RE: **Lot 14 Block 8 Unit 22 SAD 228  
6419 Canavio NW  
Volcano Cliffs Subdivision  
Grading and Drainage Plan  
Engineers Stamp Date 4/6/2021 (D10D003D14)**

Based upon the information provided in your submittal received 4/6/2021, this plan is approved for Grading Permit.

## DRAINAGE AND TRANSPORTATION INFORMATION SHEET (REV 6/2018)

ENGINEER'S SEAL  DAVID SOULE P.E. #14522	6419 CANAVIO	DRAWN BY: WCVJ
	GRADING AND DRAINAGE PLAN	DATE: 3-24-21
 Rio Grande Engineering 1606 CENTRAL AVENUE SE SUITE 201 ALBUQUERQUE, NM 87106 (505) 872-0999		210210034-LAYOUT-3-24-21
		SHEET #
		JOB # 21021034

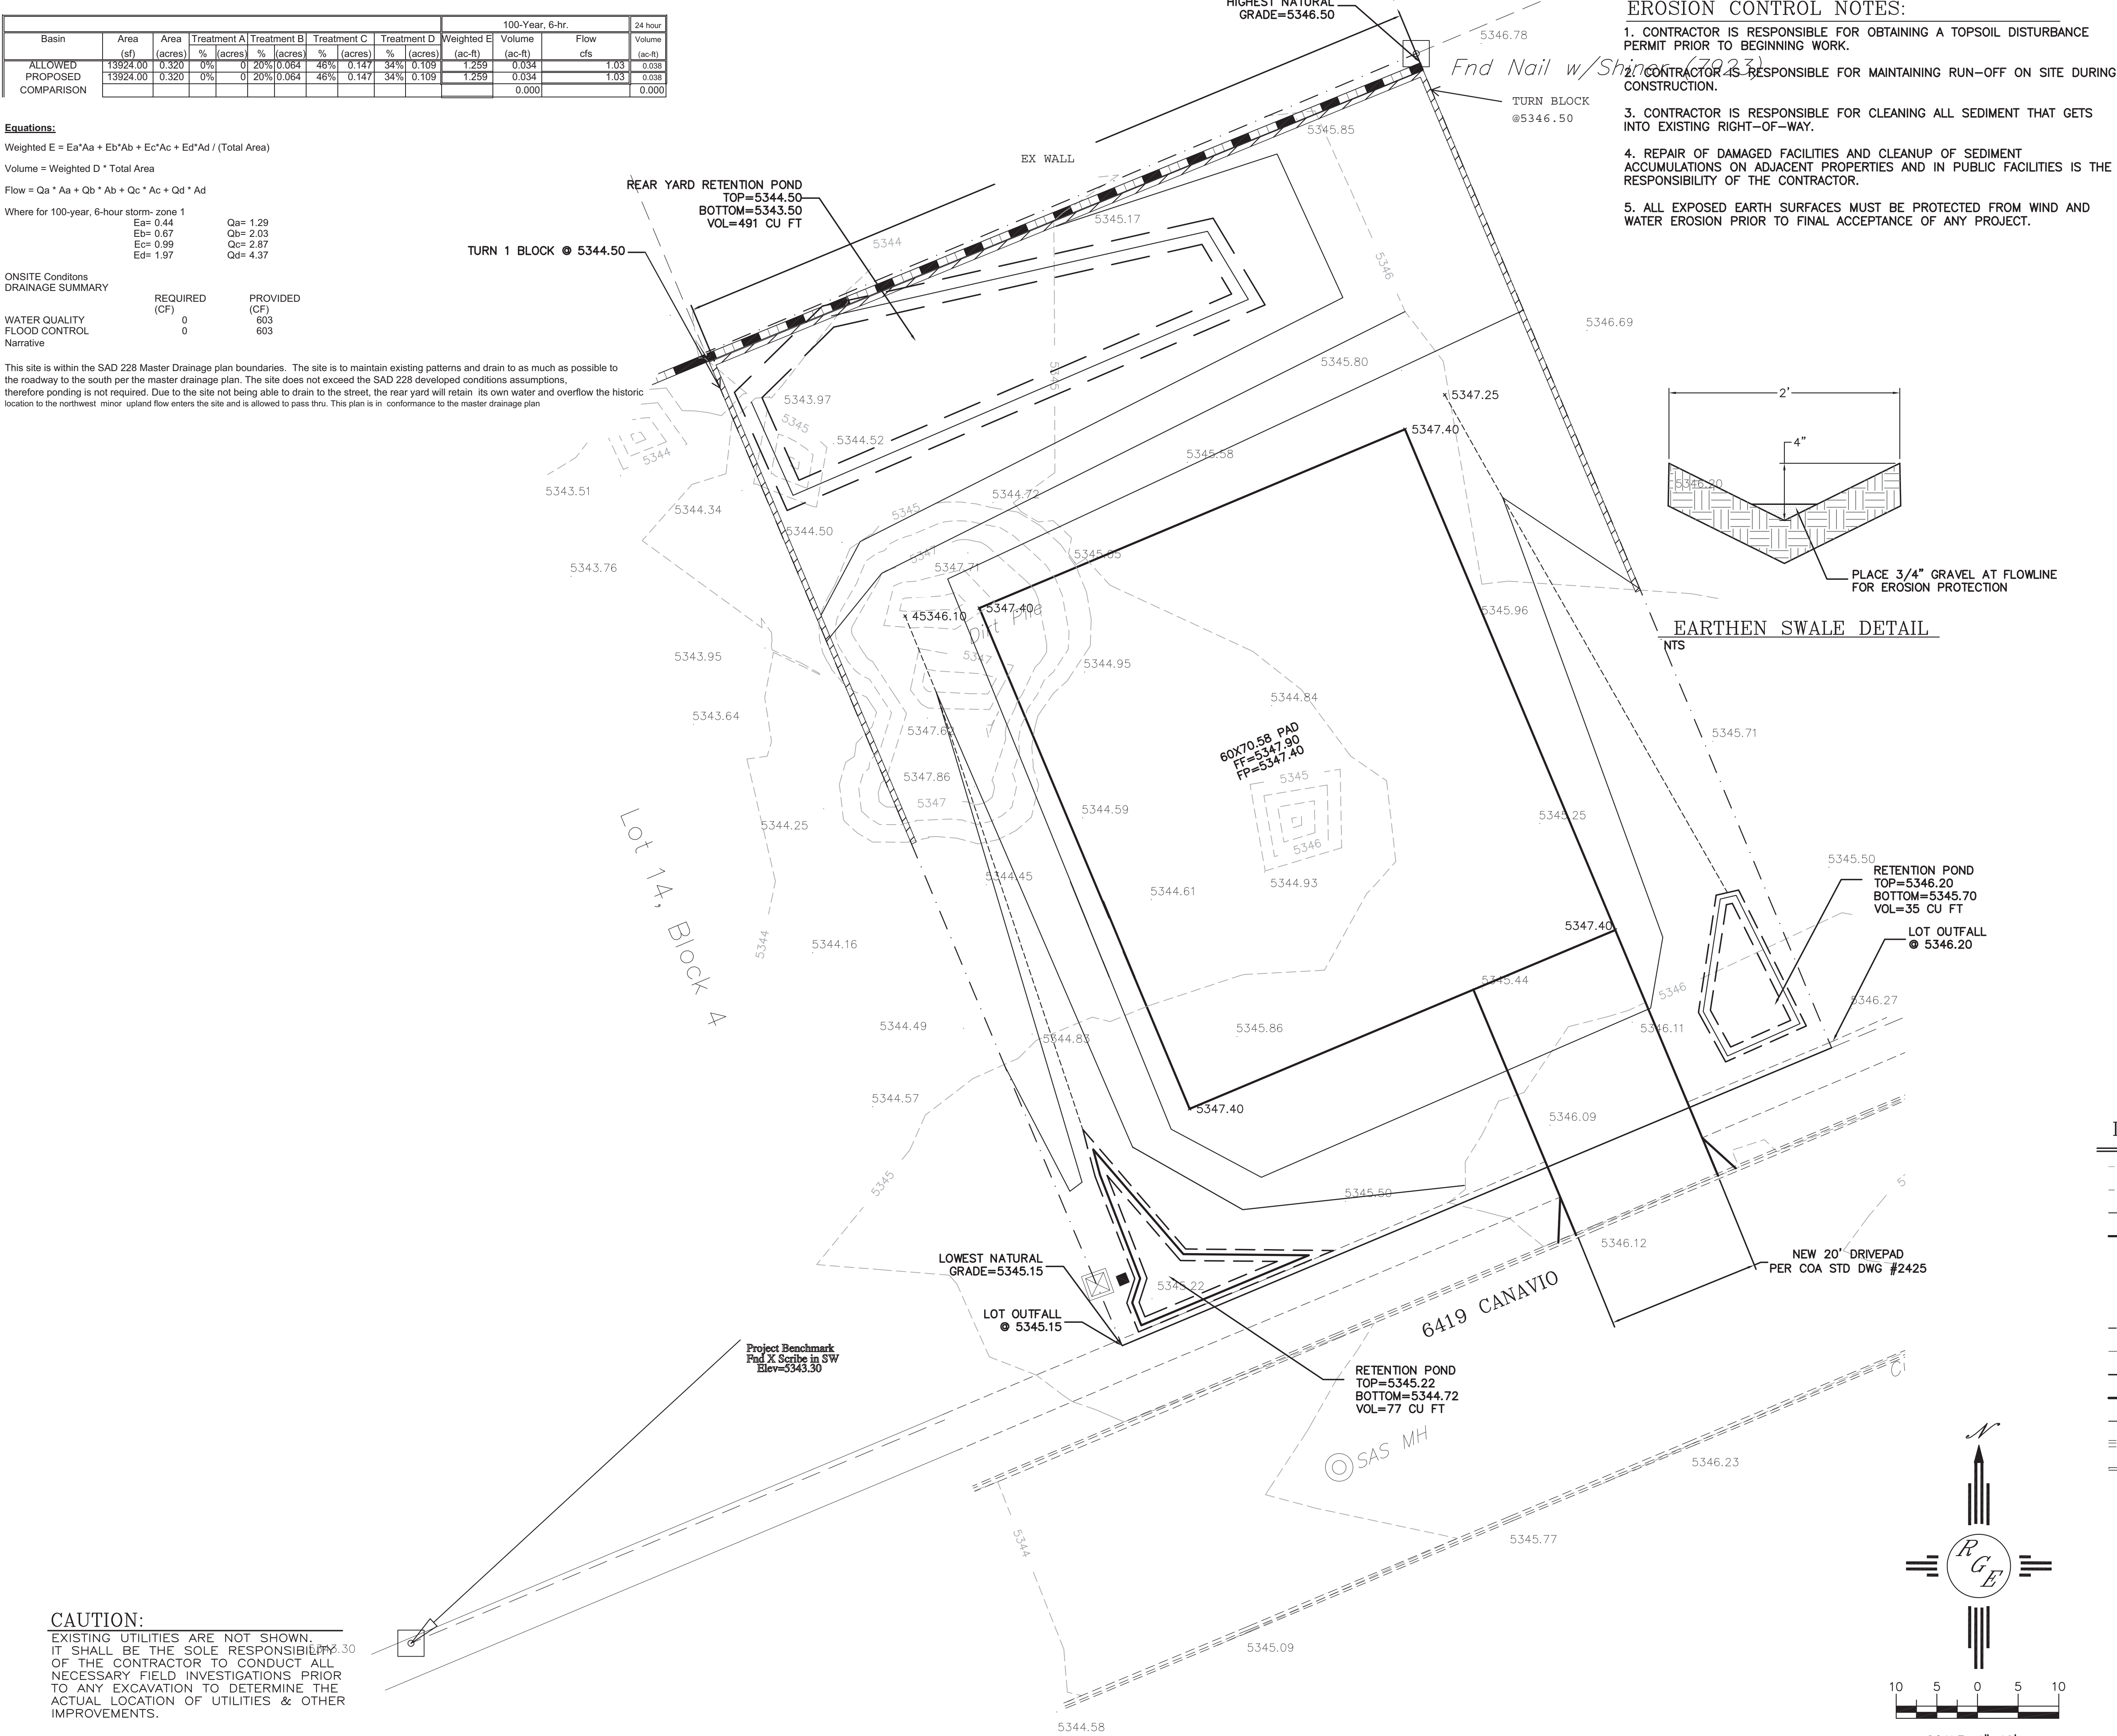
**Prior to Building permit approval a Pad Certification will be required, provided by the Engineer or a registered Land Surveyor.**

**Advise the owner contractor not to use dirt as a ramp to climb the curb, use lumber or crusher fines for this purpose.**

Reiterate to the Owner/Contractor that a separate permit for a garden/retaining wall must be obtained with the approved G&D plan and Pad Certification. Also, if a swimming pool is to be placed the grading and drainage plan will change and will need to be resubmitted.

**Prior to Certificate of Occupancy release, Engineer Certification per the DPM checklist is required.**
